## **Determination 2016/032**

# **Regarding the use of existing drains for a new dwelling at 175 Orangi Kaupapa Road, Northland, Wellington**

Appendix B Figure 1: Ground floor plumbing and drainage plan as approved (not to scale)

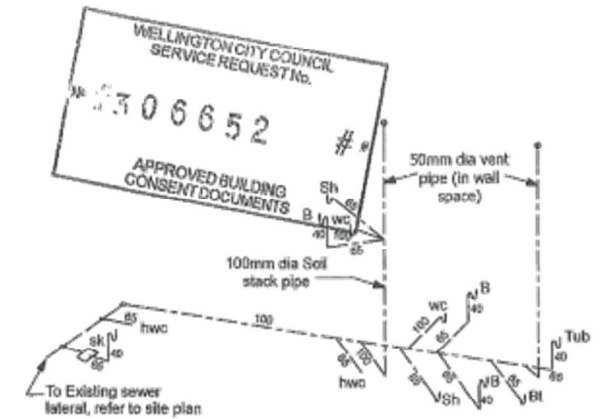
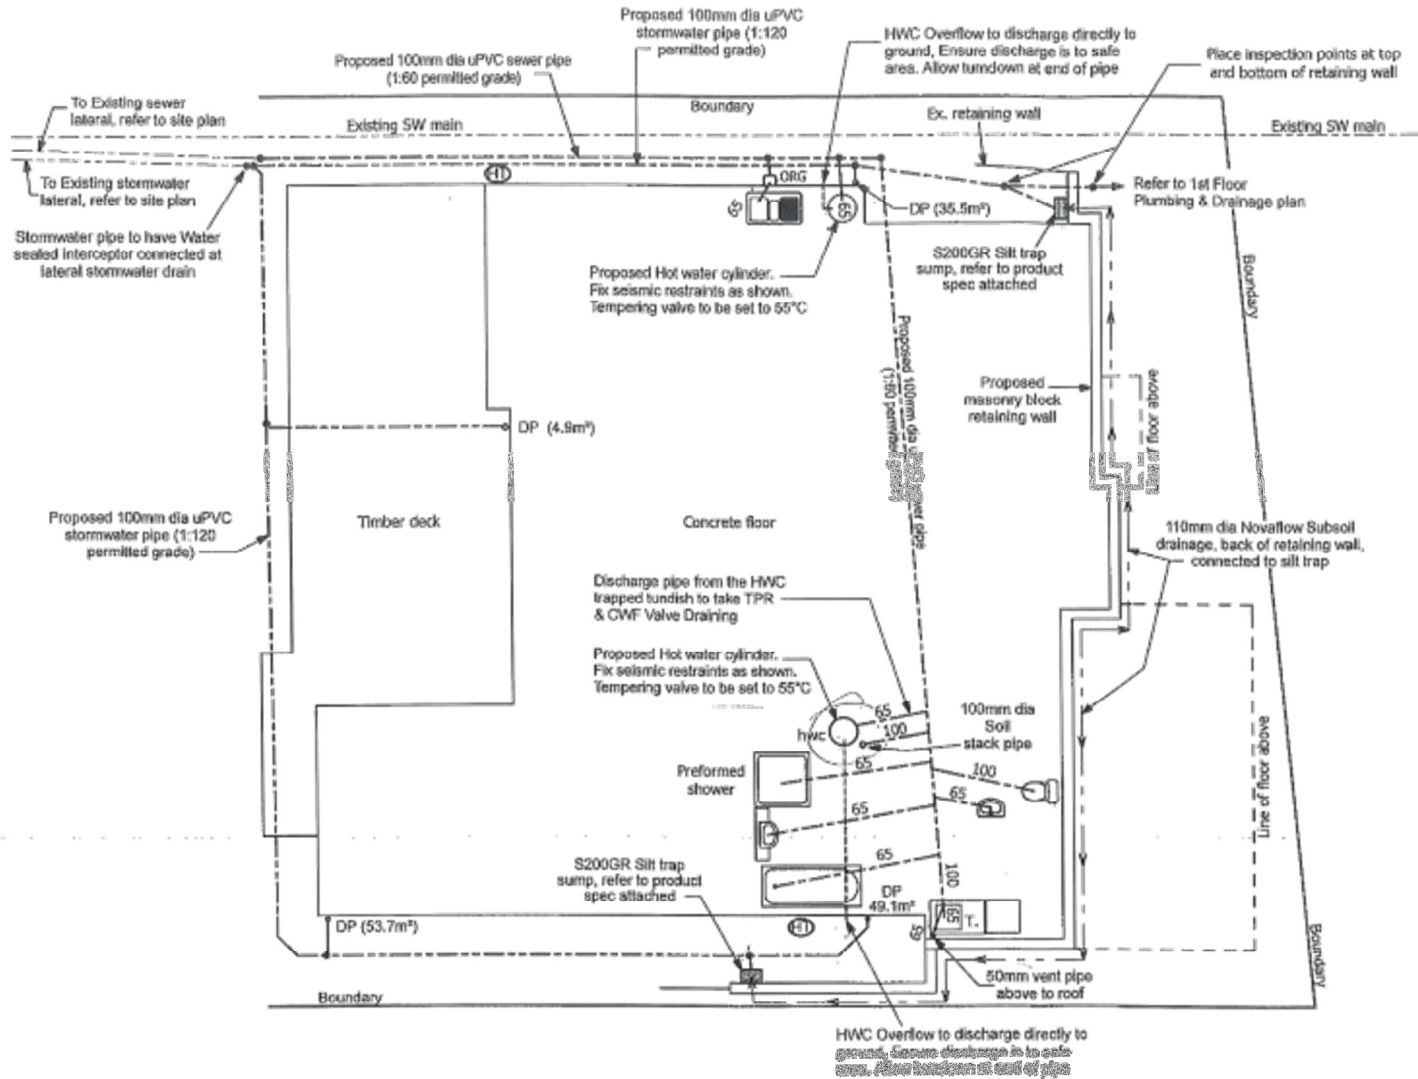
- A notation on the site plan (sheet 2) in respect of the ‘sanitary sewer lead’ and ‘stormwater lead’: ‘Services to be capped off till reused for New Dwelling’.
- Ground floor plumbing and drainage plan (sheet 4) showing ‘Stormwater pipe to have Water sealed interceptor connected at lateral stormwater drain’ and both surface water and sewage connecting to existing laterals.

The existing ceramic drain, as per the video report submitted indicates defects in the system. G13 also relates to the connection to an existing system must be proved sound. Prior to the issue of [a code compliance certificate], the drainage system shall be fully replaced to the WCC mains.

- 4.10 Given that the replacement of the existing drains was not required as a condition before the building consent was granted, I am of the view the authority incorrectly exercised its powers of decision in requiring this work be carried out. I note here that it was open for the authority to issue a notice to fix to address the testing requirement in accordance with the Standard cited in the building consent.

- 5.1 In accordance with section 188 of the Act, I hereby determine the authority incorrectly exercise of its powers of decision in requiring the existing drains to the property be replaced after the building consent was issued.

**Appendix B Figure 2: Drains as recorded on GIS**

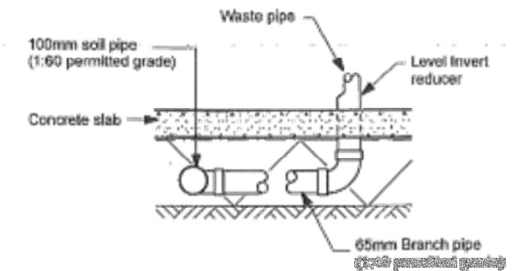
The sewer and surface mains both are wholly within the property, with both private connections to the mains occurring within the property boundary at the northwest (see Appendix B Figure 2).

Extend the as laid plan to include where the drains discharge to, in relation to the WCC mains.
